File: nautilus_mainboard.kicad_sch

Sheet: /STM/

Sheet: /Piezzo/

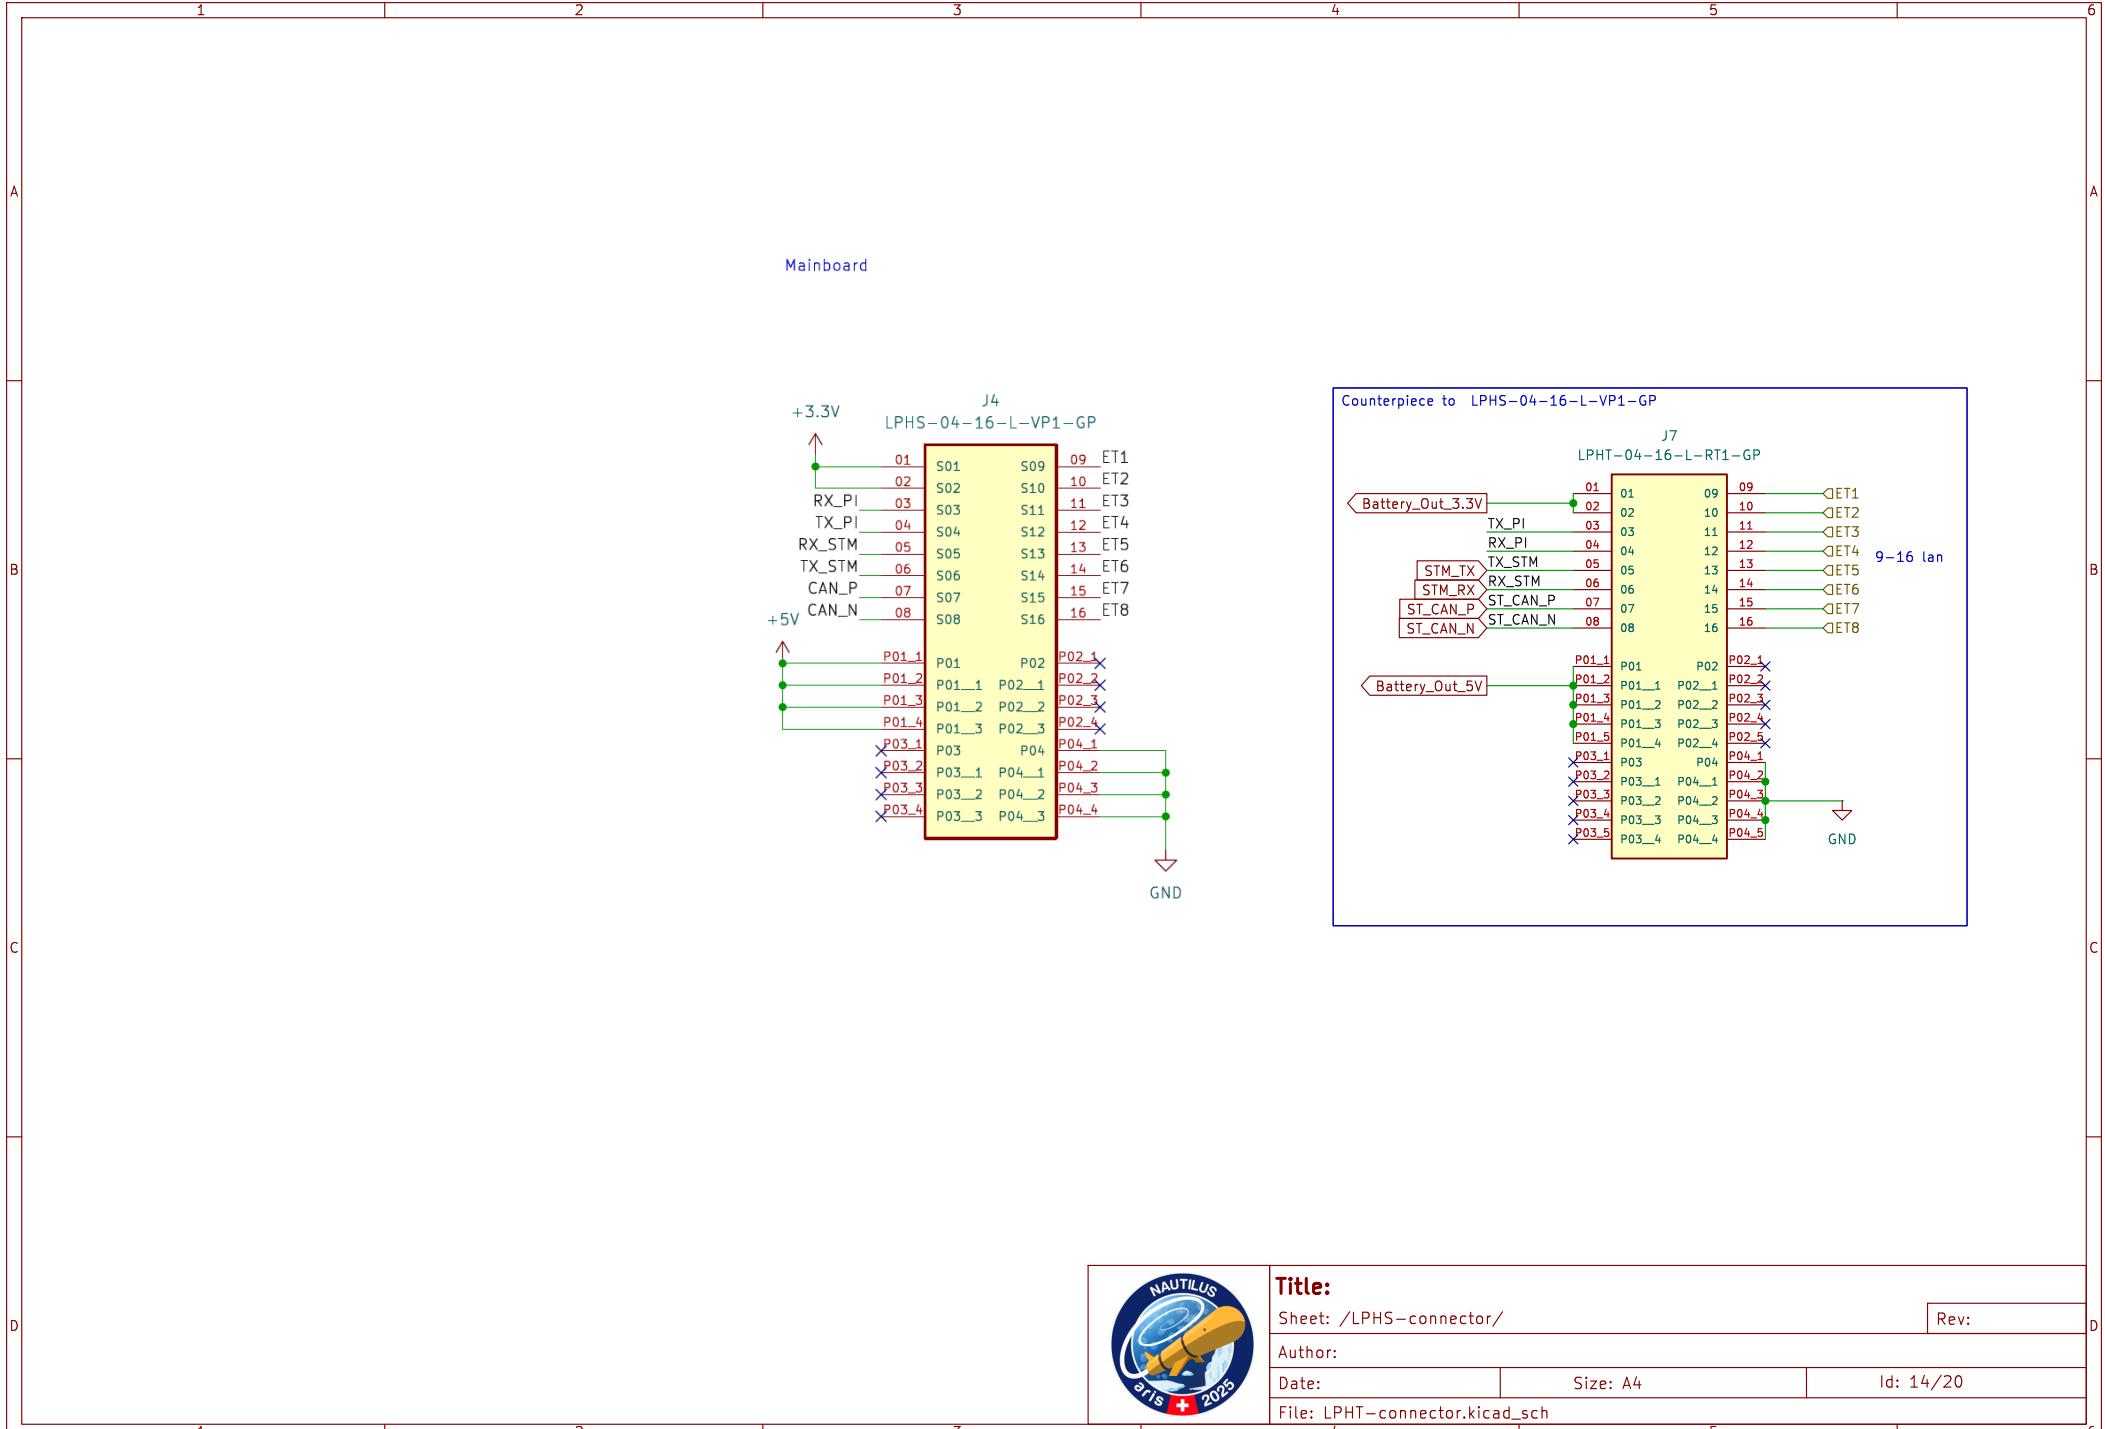
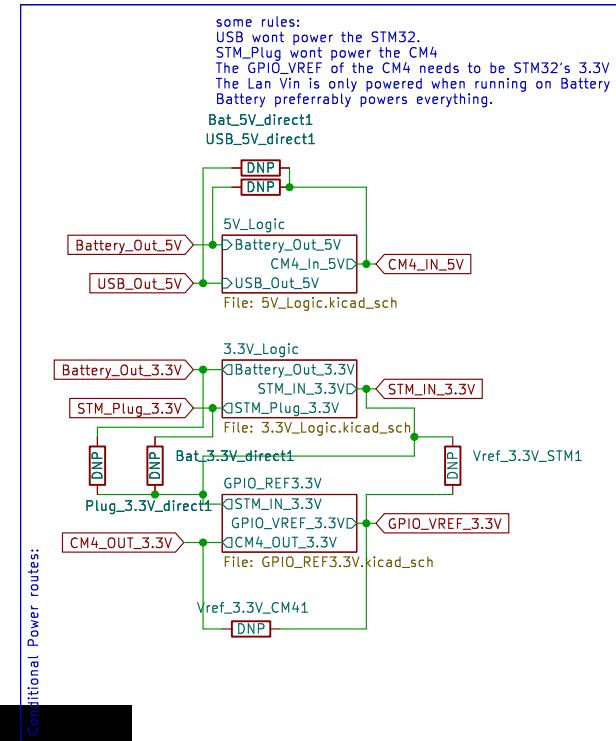
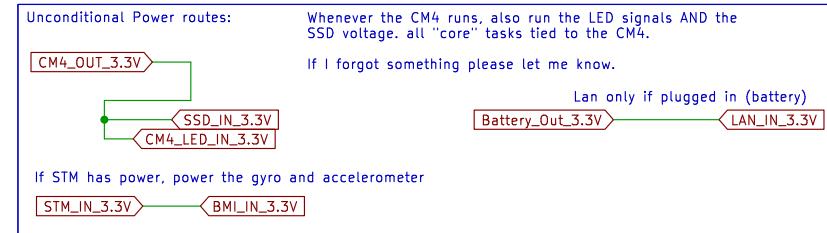
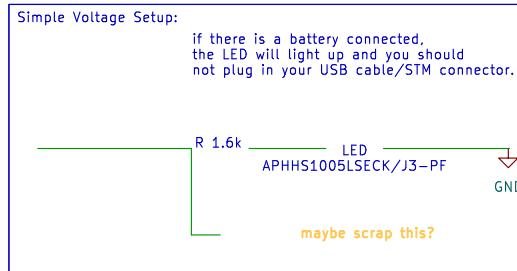
Wont work... diodes are not perfect...

Sheet: /STM/CAN_Interface/

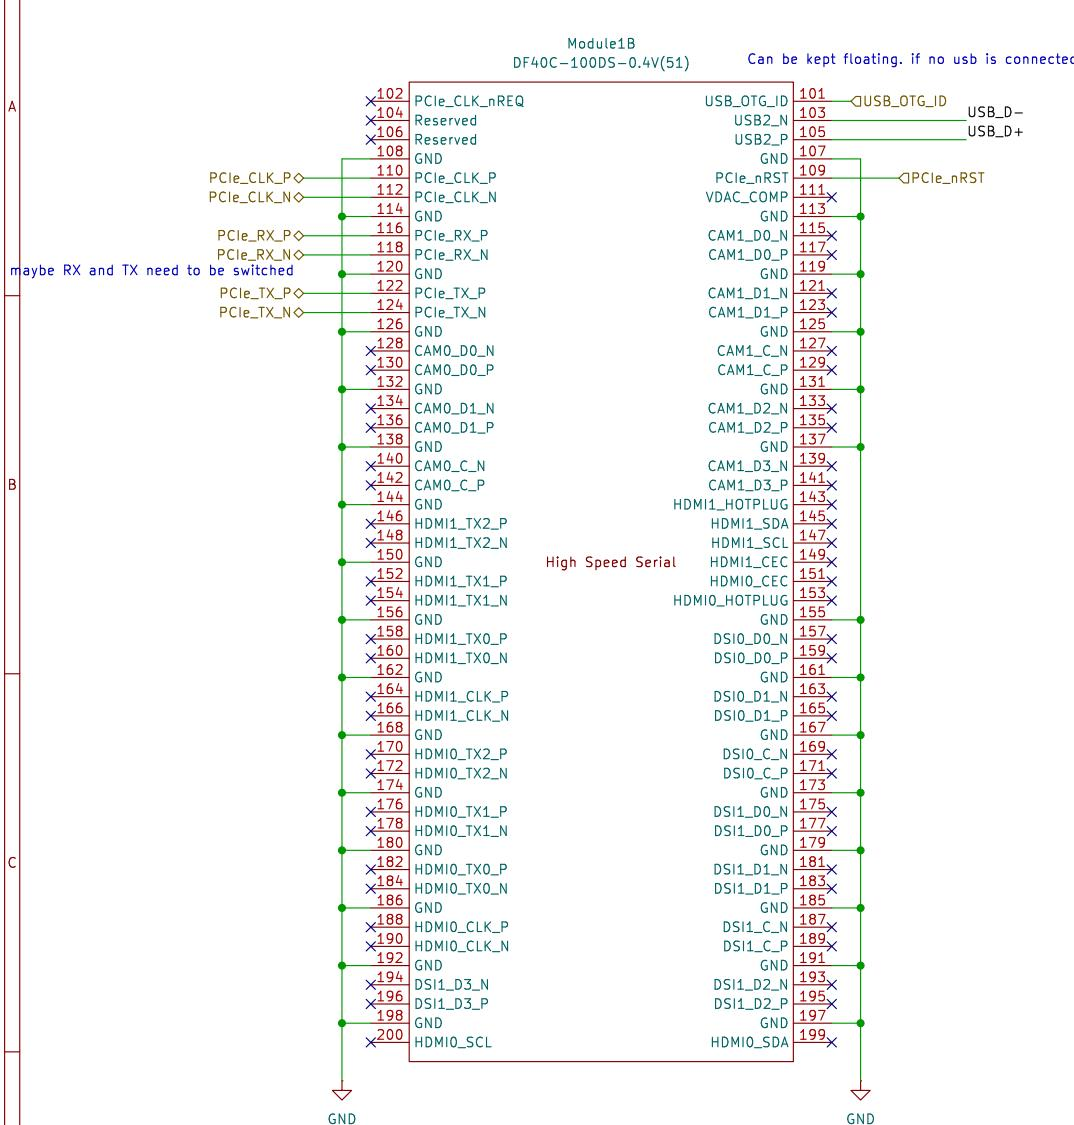
ESD/EMP protection for the USB
Super important to not differ lengths or curve a lot with D+ and D-.
Also should have same hole counts (vias) and same length.

WIP, nRPI_BOOT? power only to certain parts? → Diode (later)
indication? (YES! LED)

Sheet: /CM4/PCIE_Interface/

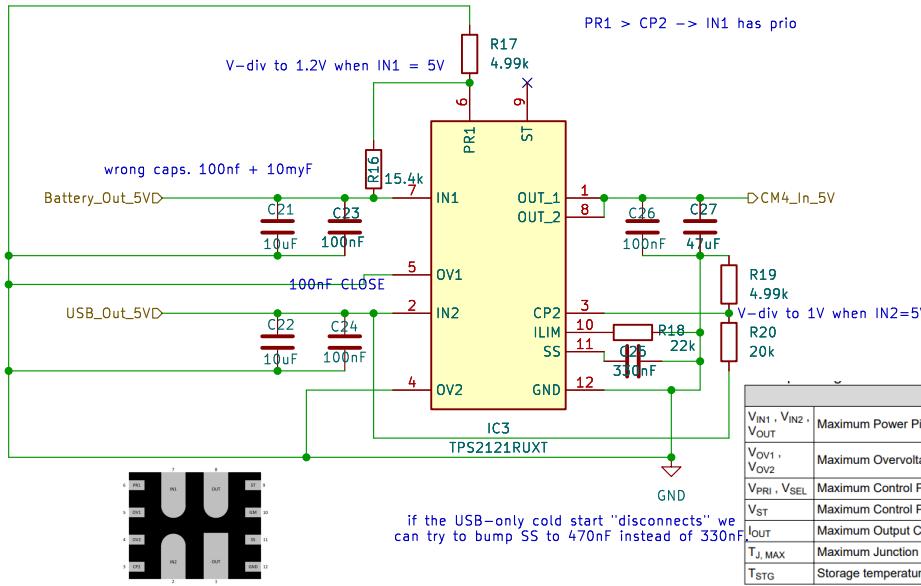
for questions about wiring etc please consult the datasheet..
<https://www.ti.com/lit/ds/symlink/tps2120.pdf?ts=1761678178328>
